ADDENDUM NUMBER 1

INVITATION TO BID #19-036

Intersection Improvement Project T-7238 at Johnson Ferry Road and Riverside Drive

CHECKED:	DATE:	DRAWING No. 23-0001
BACKCHECKED:	DATE:	
CORRECTED:	DATE:	
VERIFIED:	DATE:

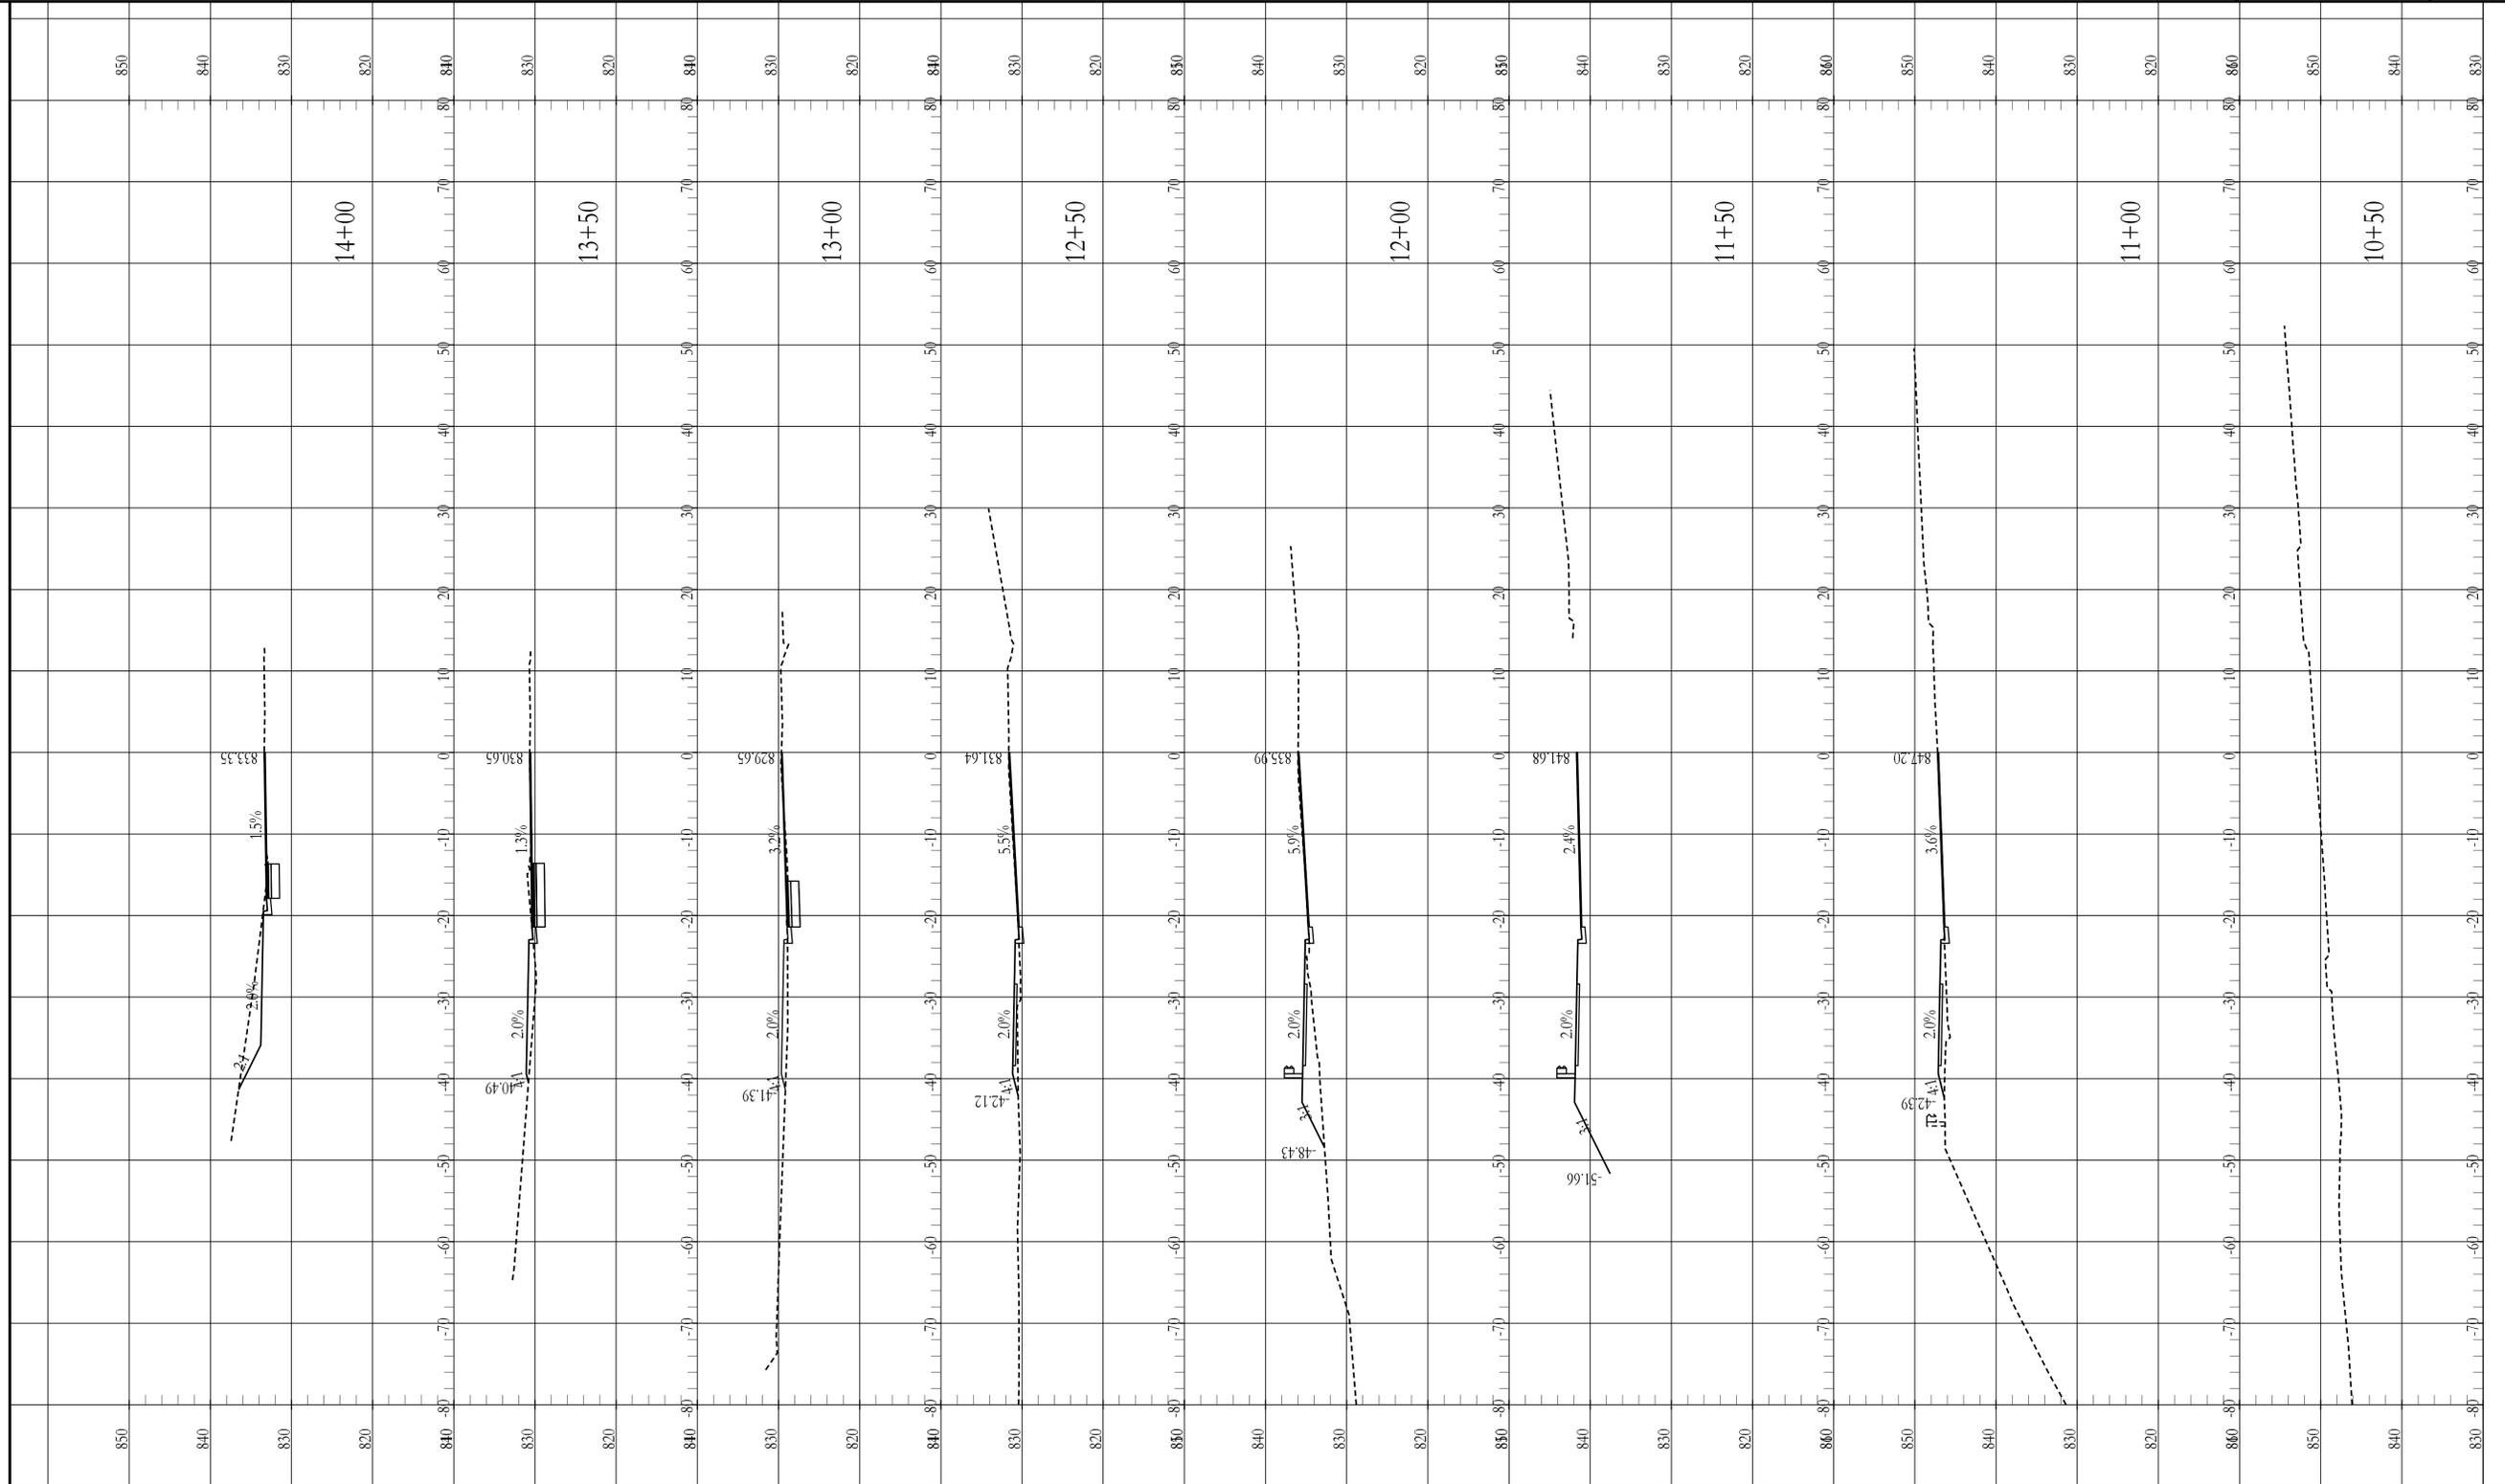
2) The typical section, as well as the mainline plan for Riverside Dr. shows Full Depth Asphalt but the cross section does not reciprocate this. Can we get the engineer to revise this in order to figure how much grading will be done in this location?

'24-0001&0002 (xs) – Added full depth pavement areas to the Riverside cross sections

A: The plan and typical section are correct. The plans has been revised to show Added full depth pavement areas to the Riverside cross-sections.
